CALIFORNIA COASTAL COMMISSION

REGULAR CALENDARSTAFF REPORT AND PRELIMINARY RECOMMENDATION

Application No.: 6-99-118

Description: Relocation of an existing sewer lift station 180 ft. to the south and the replacement with a new sewer lift station including an above-ground emergency generator and electrical panel with paving, landscaping, fencing and installation of a curb cut on the street frontage on an approximately 2,000 sq.ft. site.

| Site Plan |

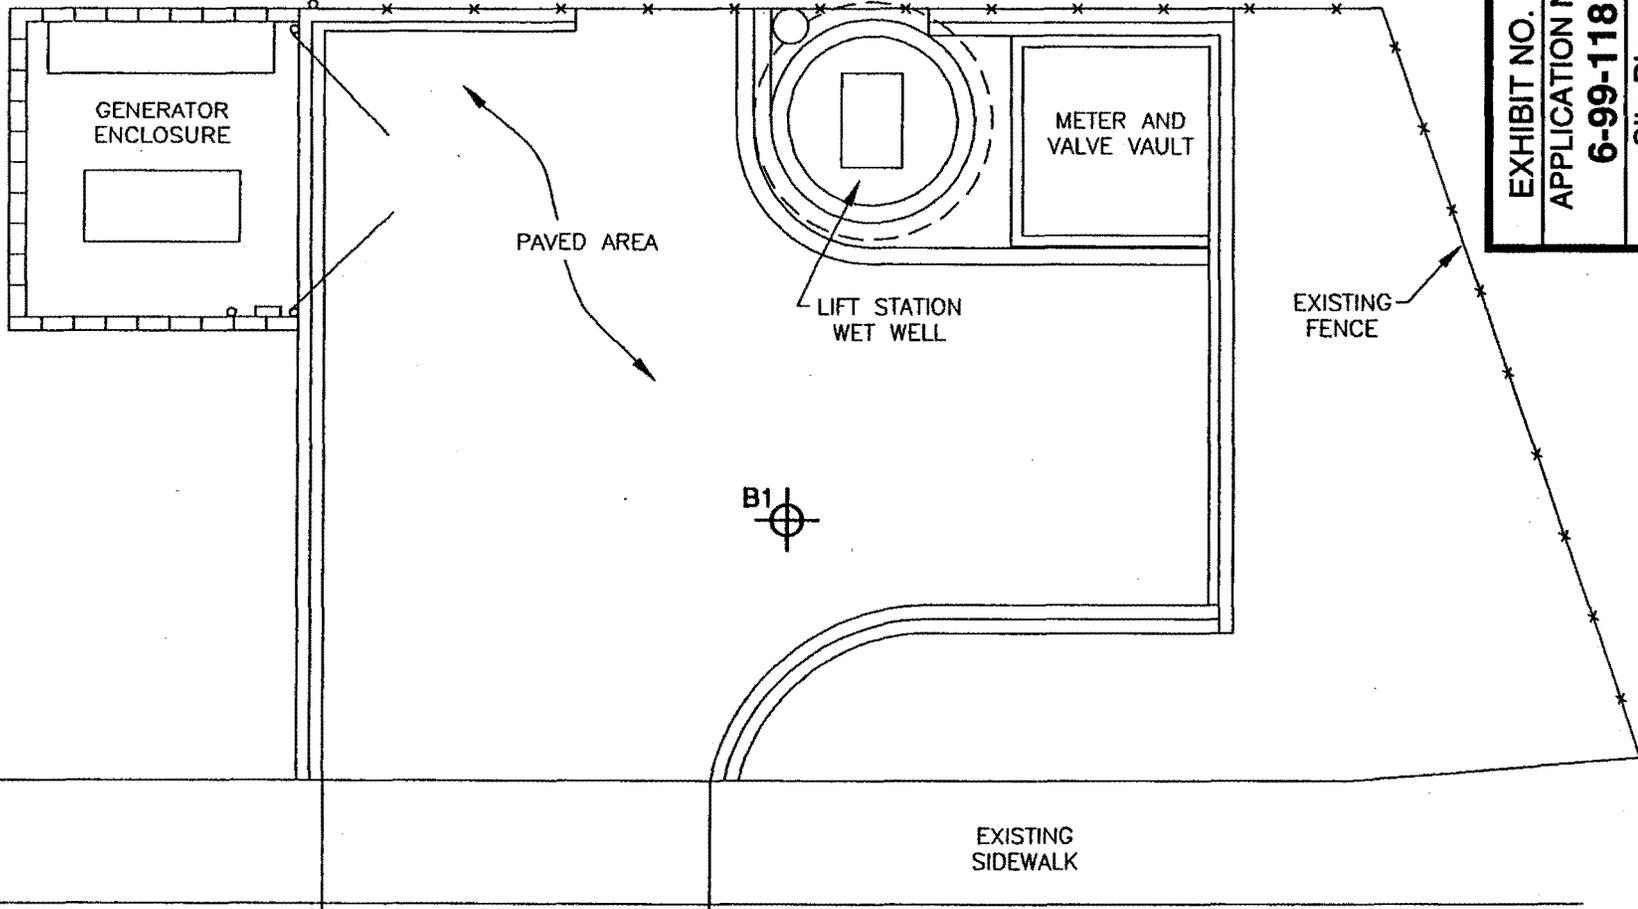
- a. Implementation of routine sweeping program for the driveway/turnaround area and paved pedestrian walkway of the project site as shown in Exhibit No. 2.
- b. Installation of a hydrocarbon filter inside of the curb inlet on the east side of Carlsbad Boulevard immediately west of the project site.

| Landscape Site Plan |

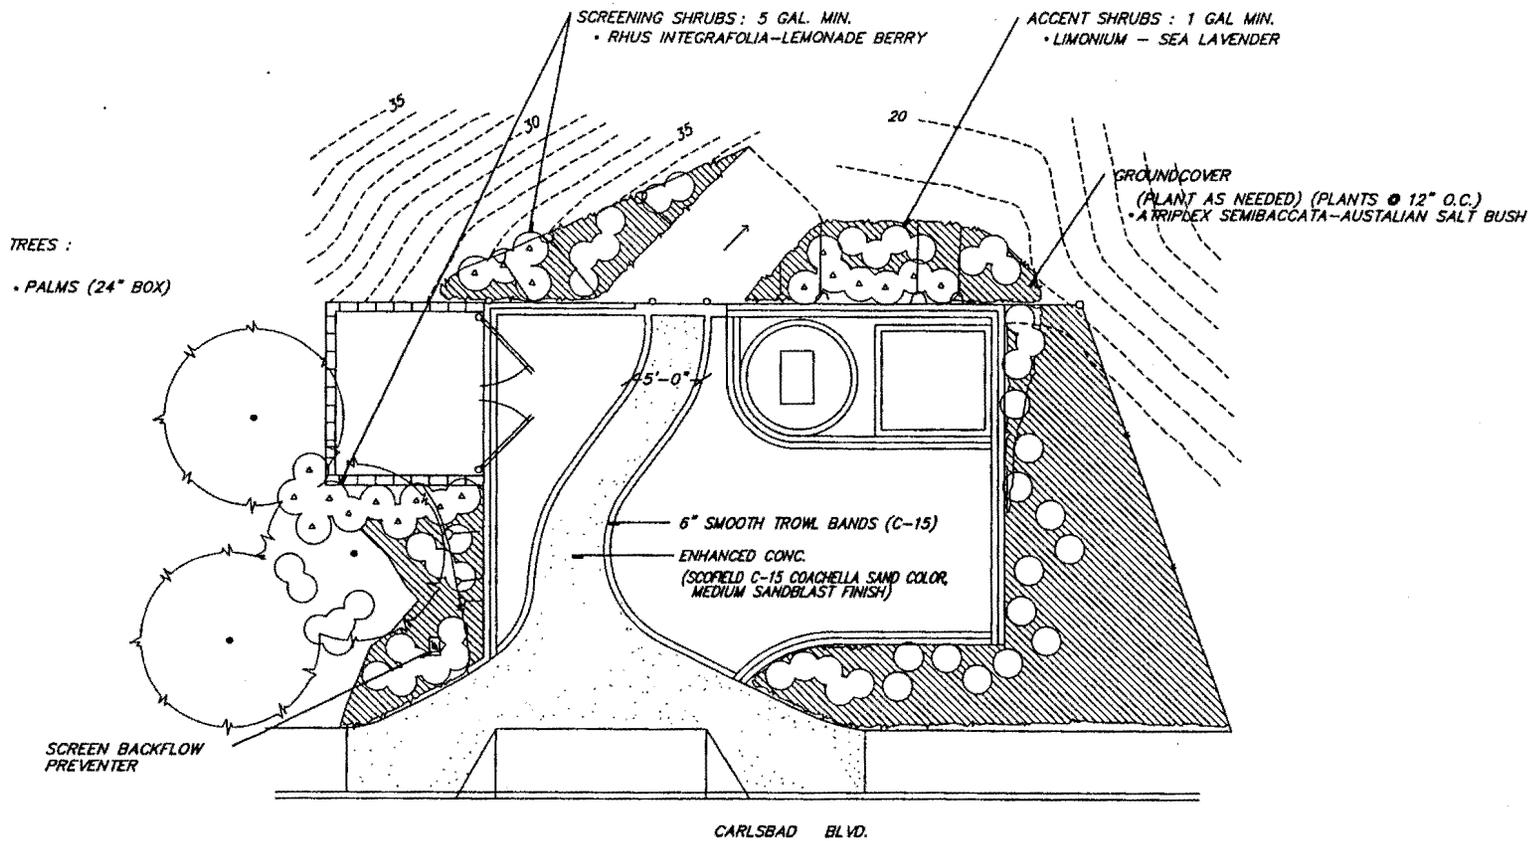
1. Landscape/Retaining Wall Plans. PRIOR TO ISSUANCE OF THE COASTAL DEVELOPMENT PERMIT, the applicant shall submit to the Executive Director for review and written approval, a final landscape plan. Said final plan shall be in substantial conformance with the submitted plan by Carlsbad Municipal Water District dated 4/29/99, developed in consultation with the California Department of Fish and Game and shall be revised to include the following:

- a. The installation of plant materials consisting of native, drought-tolerant, fire resistant materials. No invasive or exotic plant species used (i.e., iceplant, etc.).

The plan shall also indicate the type, size, extent and location of all plant materials, the proposed irrigation system and other landscape features.
